FIRE SAFETY INSPECTION REPORT

Factory Name: Sublime Greentex Limited

Date: 25 February, 2018.

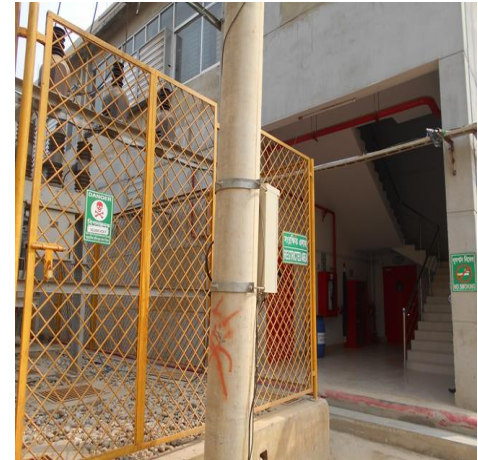
Sl No.	Category	Findings	Required Action	Remediation Time Frame	Pictorial Evidence
1	Fire Rated Construction	The exit stairs are not separated from [work areas, other spaces] on each floor by fire-rated construction. Location: Building 1 & Building 2.	Stair shall be enclosed with a minimum 2-hr fire-rated construction. Seal all unprotected openings and provide minimum 2-hr fire rated doors to separate the exit stairs from work areas and other building spaces on all floor levels. Ensure that the fire doors are self-closing, positive latching and that they are provided with fire exit (panic) hardware where serving production floors. If fire doors are required to be held open for functional reasons, provide automatic-closing devices tied to the fire alarm system. Note: The gap between floor level and fire door was not found as per standard, door co-ordinator & door closure was found missing during inspection. Also, fire door was found held open by external forces.	Within 3 months

3

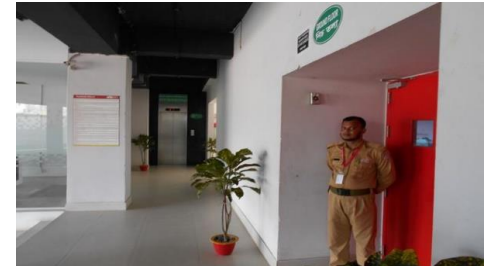
The exit stairs discharge inside the building to the ground floor.
Location: Building 1.

Modify the stairs to discharge directly outside.
Alternately, provide 2-hr fire rated exit passageway leading directly outside (vestibules to separate any storage areas).

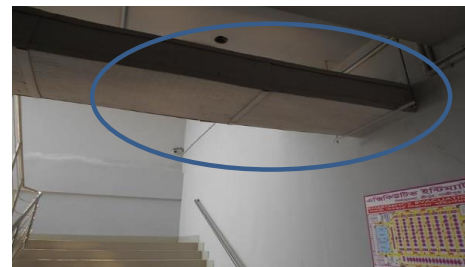
5	Fire Rated Construction	Unsealed penetrations and openings are located in exit stair enclosures. Location: Building 1 & Building 2.	Seal all penetrations and openings in the wall of exit enclosure walls (full thickness of the wall) by fire rated materials to maintain the fire resistance rating.	Within 1 month	
---	-------------------------	---	--	----------------	--

7

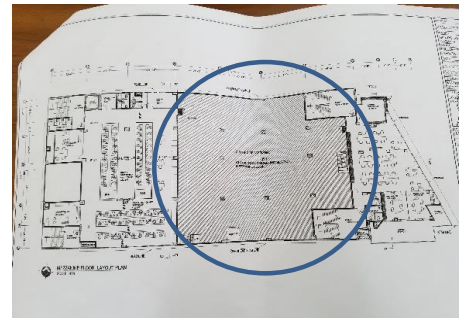
1st floor of Building-1 has 3 parts. One part (Middle Part of the floor) is Pre-fabricated steel (Part-1) which is non-rated structure and another 2 parts is RCC frame (Part-2 & 3). Part-1, Part 2 and Part-3 are not physically separate buildings but have a structurally independent fire wall separating them. From visual inspection all those structural members were found free of damage during assessment.

Since the structure is steel-composite type and all the RCC panels are resting on the steel beams and slab. Hence, ground & 1st floor of the building is not separated by a fire resistive rated protection construction barriers.

Provide fire-resistive rated construction barriers between floors following Section 4.4 and Table 4.4.1 of the Accord Standard or Table 3.3.1 and Table 4.1.1 from BNBC Part 4. Consult a qualified fire protection engineer to design the rated construction barriers.

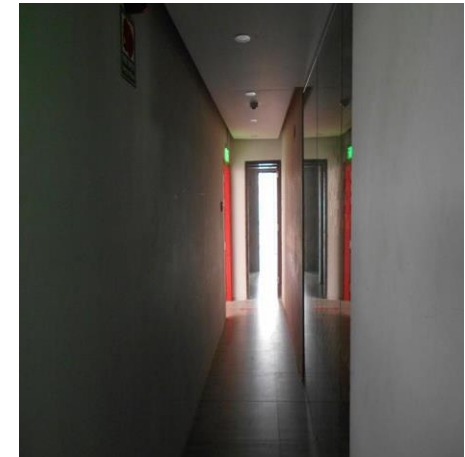
18	Egress Lighting	Based on the number and location of emergency lights observed, adequate illumination levels are not anticipated along egress routes. Location: Building 1, Building 2.	Test the emergency lighting system on each floor and provide additional emergency fixtures to provide adequate illumination along the means of egress. Provide a minimum illumination of 10 lux at the floor level within exit stairs and exit discharge paths and minimum 2.5 lux along exit access aisles.	Within 3 months	
----	-----------------	--	---	-----------------	--
